STAFF REPORT

REGIONAL CENTER HEARING EXAMINER - HIGH IMPACT CASE

Case Number	2025-REG-016
Address (approx.)	238 and 240 South Pennsylvania Street
Location	Center Township, Councilmanic District # 18
Petitioner	Boxcar Development, LLC., by Timothy E. Ochs
Zoning	CBD-2 (FF) (TOD) (RC)
Request	Regional Center Approval for provide for updated plans for a three-story entertainment venue, previously approved through 2024-REG-046.

SITE PLAN - SCALE: 1" = 20'-0"

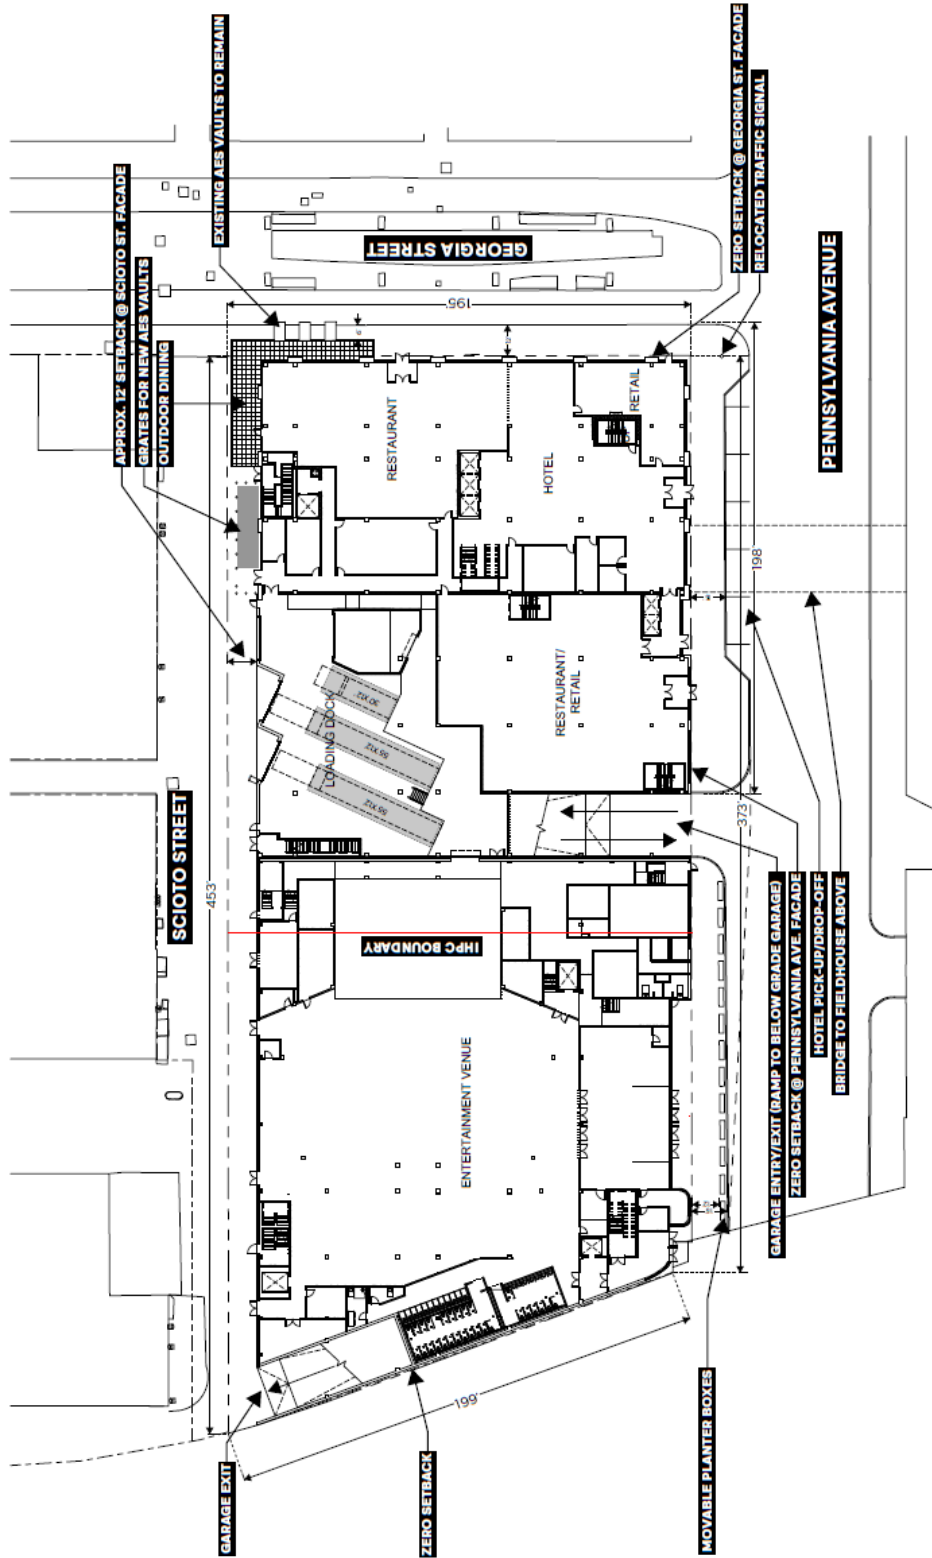
The proposed building material would be mostly brick, clear vision glass, and metal, with a marquee over the entrance to the facility. Previously, the entry proposed a canopy. The marquee is one change that is substantial, and supported as it quickly identifies the structure as an entertainment venue. Another change is the inclusion of vertical windows in the larger brick façade area, that previously had little interaction with the pedestrian way. A third change is the reduction of windows at the entrance to the facility. Additionally, the roof would be usable for events and gatherings, with a potential of an art piece. The site plan indicates a number of movable planter boxes along the street. No details of these planter boxes were submitted to the file.

EXTERIOR DESIGN MATERIALS - EAST ELEVATION

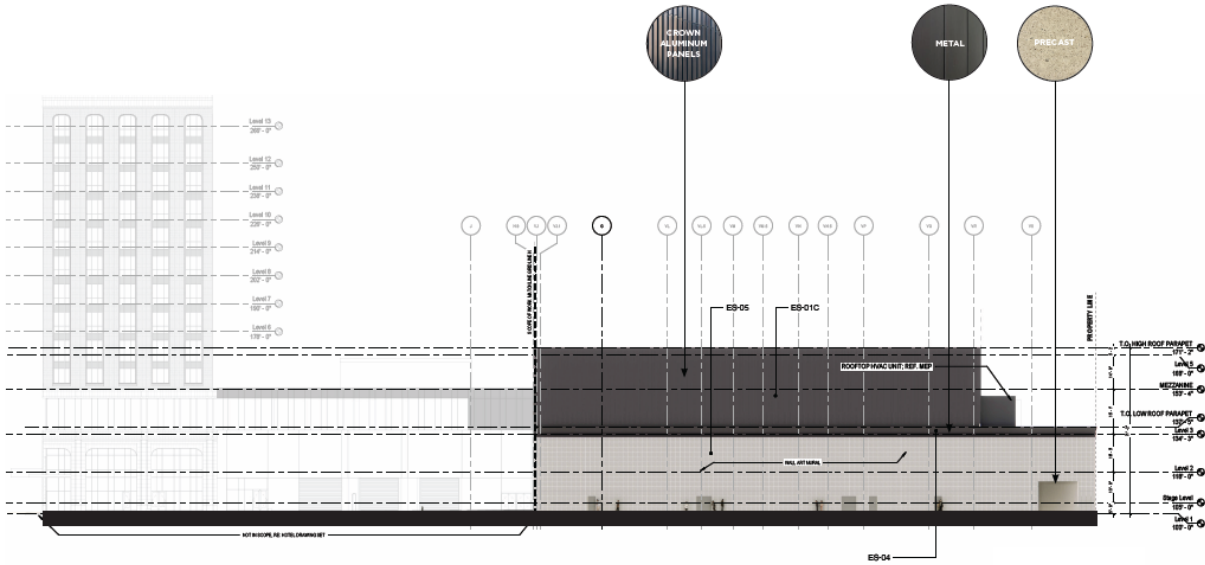
1. The revised design is an improvement over the previously approved design in that new windows are proposed in an area that previously would be large brick wall, with little interaction with the pedestrian way. Staff would request details to be submitted of the proposed east elevation 'wall art mural' before installation. Guideline CA 1.2.1 applies.

1. The Summary items shall be met.
2. That 'wall art mural' details for the east elevation shall be submitted for staff review and approval prior to installation.
3. All signage within two years of MDC approval requires planning staff review and approval. After the two-year period, a new Regional Center Approval petition would be required for review and subsequent approval of any proposed signage.
4. Address numerals shall be installed on the building façade (CA 2.5.8) prior to occupancy of the building.
